MCA 412

Order of Authorized Officer

Conoco Phillips
MCA Unit - 412, API 3002538980
T17S-R32E, Sec 33, 10FNL & 2150FEL
June 02, 2015

Schematic - Current

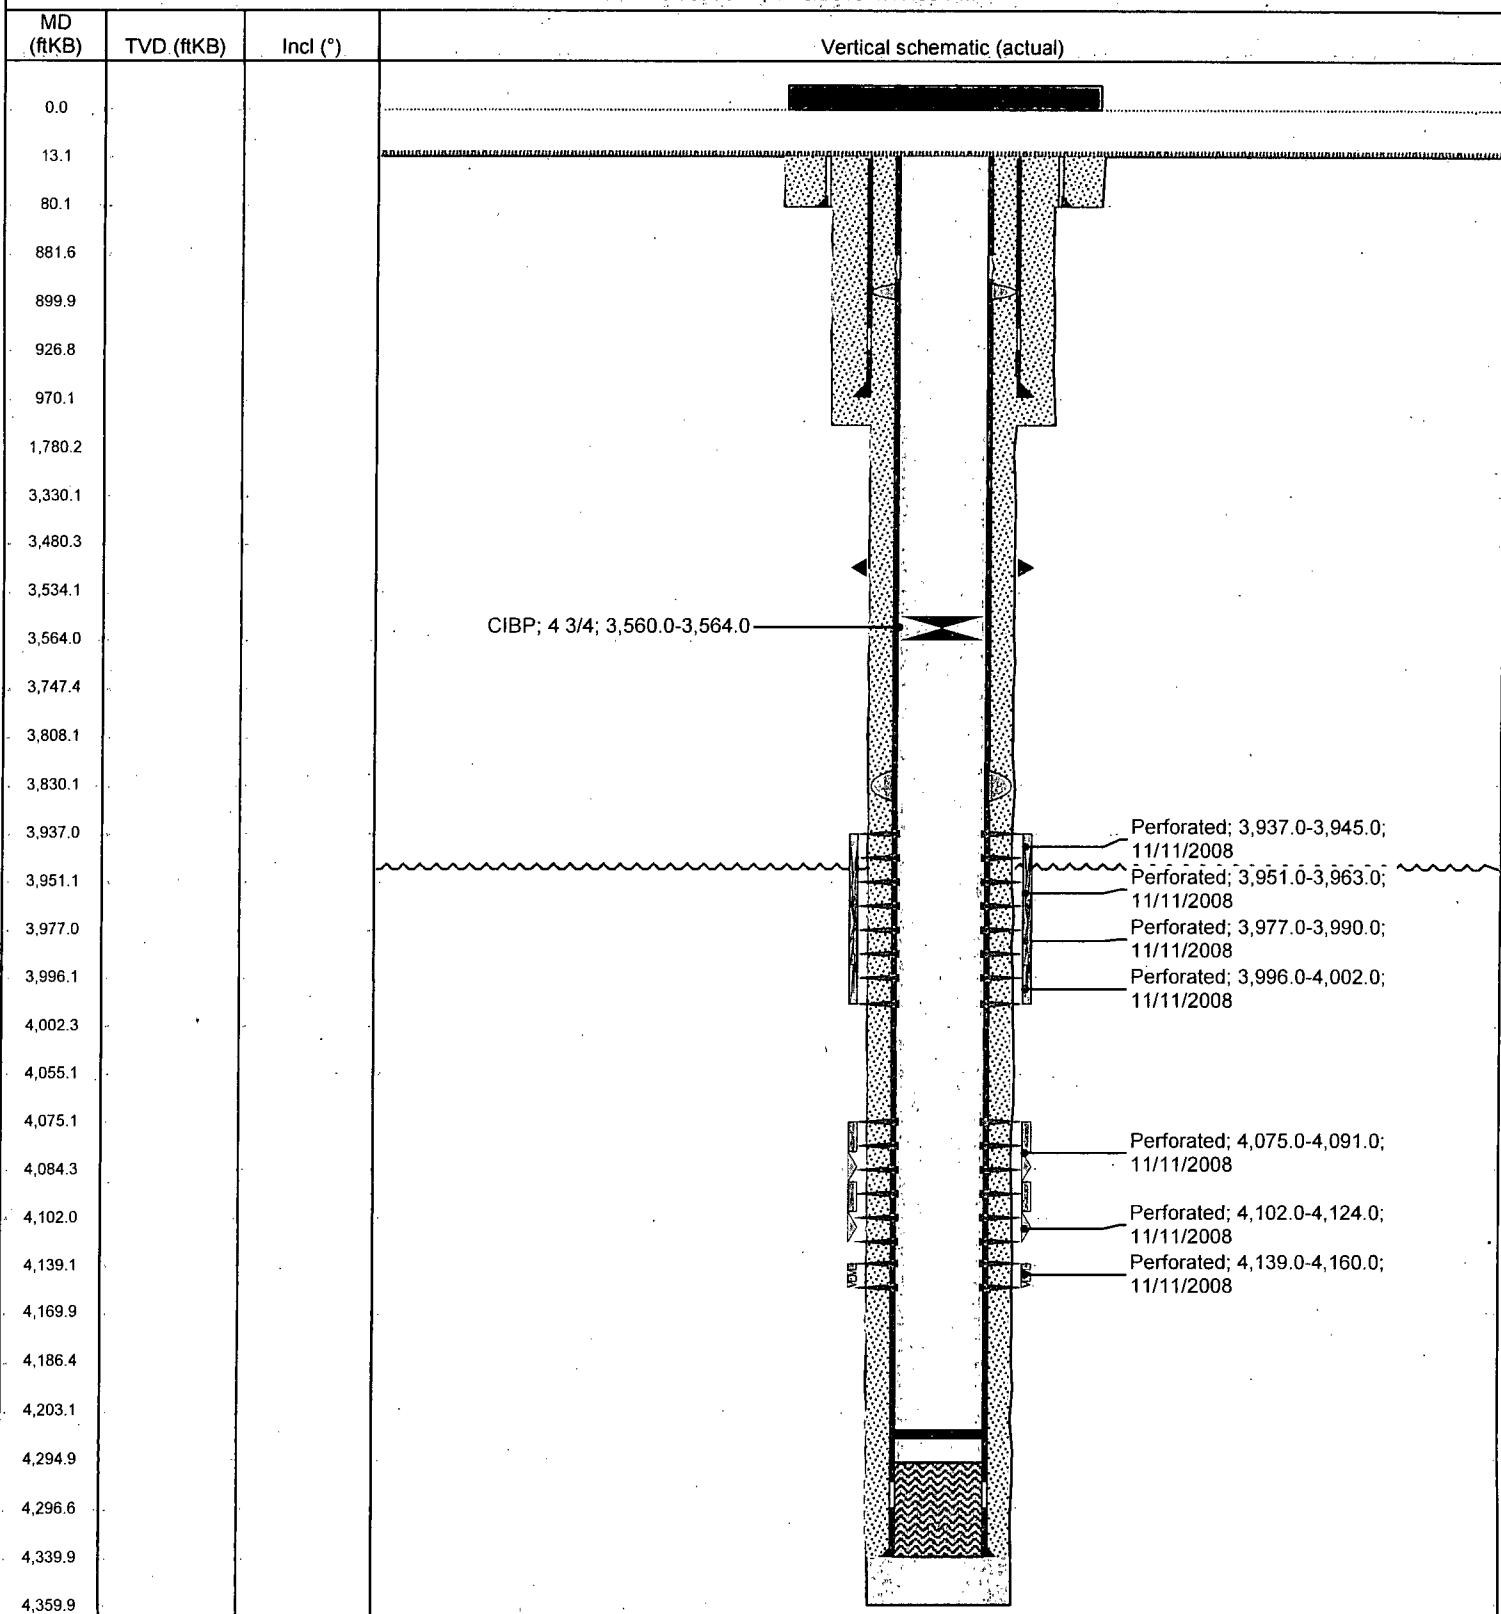
This well's recorded activity appears to have been inactive/shut-in for more than 30 days without authorization. An inactive/shut-in well bore is a non-producing completion that is capable of "beneficial use" i.e. production in paying quantities or of service use for more than 30 days without authorization. BLM compliance requires an inactive/shut-in well to be converted to temporary or permanent abandonment. A notice of intent Form 3160-5 for that conversion should be filed.

As the current operator you are required to: **Prove the production casing integrity from no more than 100 feet above the perforations or open hole with a documented minimum pressure test of 500psig for 30 minutes, and return the well to production or beneficial use on or before 08/02/2015.**

Should the mechanical integrity test fail or not be conducted submit a procedure to plug and abandon the well for BLM approval.
